**Solicitation: F1700-120287/A**  
**Tofino – Construction of a New Residence**

**Addendum No. 3**

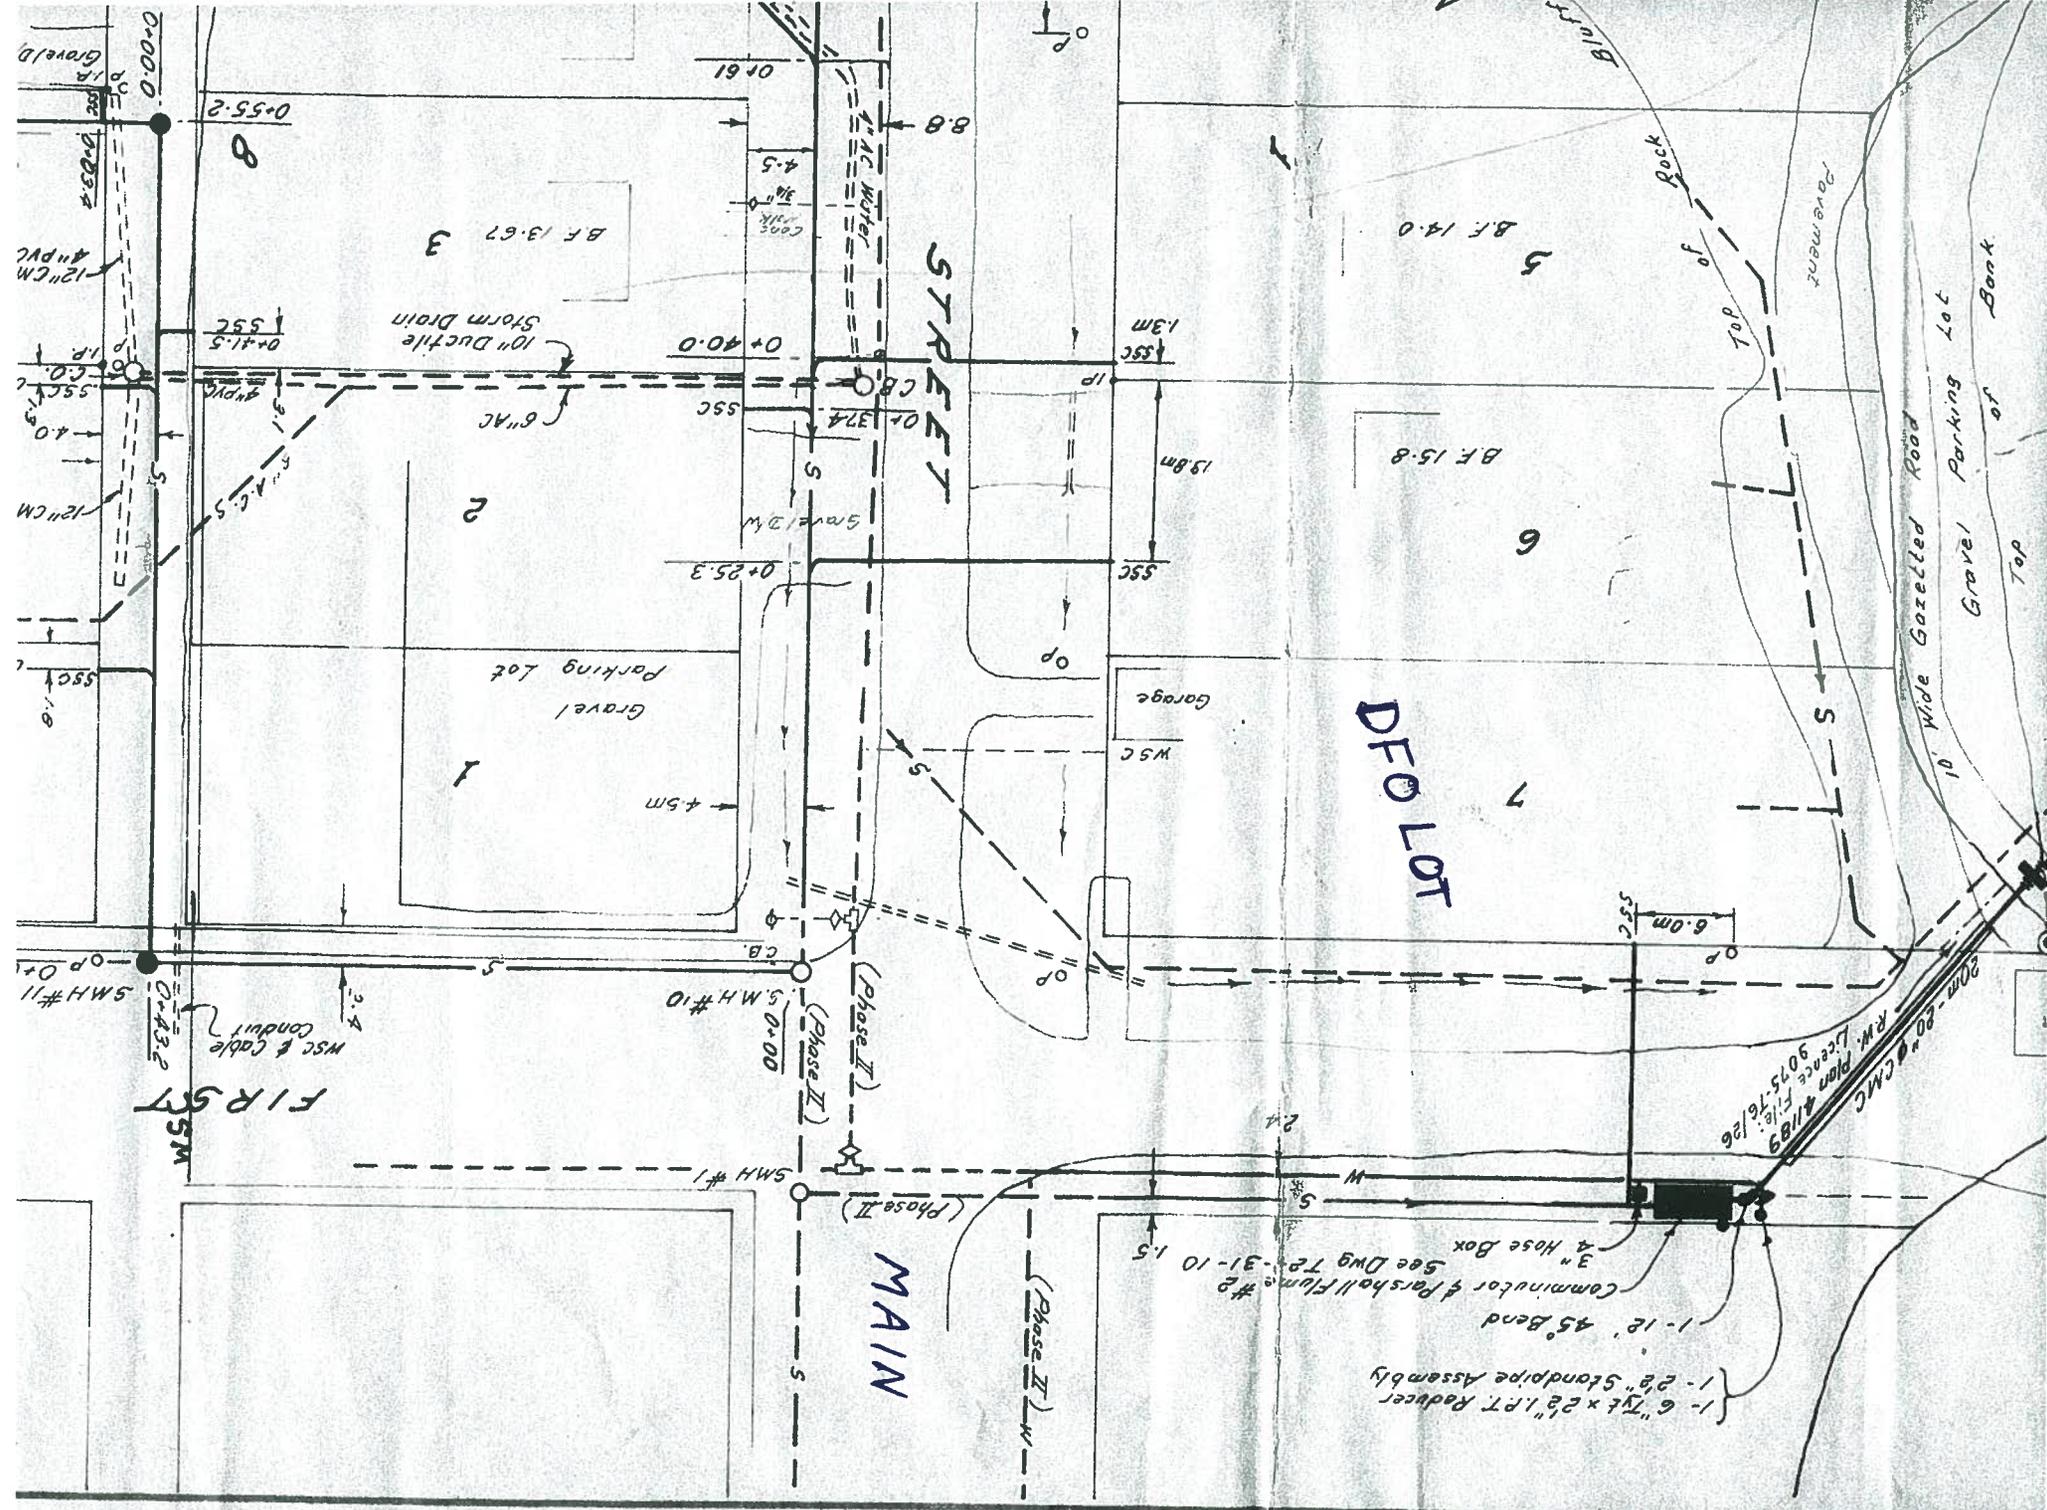
- 6. Tie-in locations for new utility services (eg. Water and sanitary).**

Please see attached drawing “Main & First – City of Tofino Plan” for the existing city of Tofino water and sanitary sewer locations.
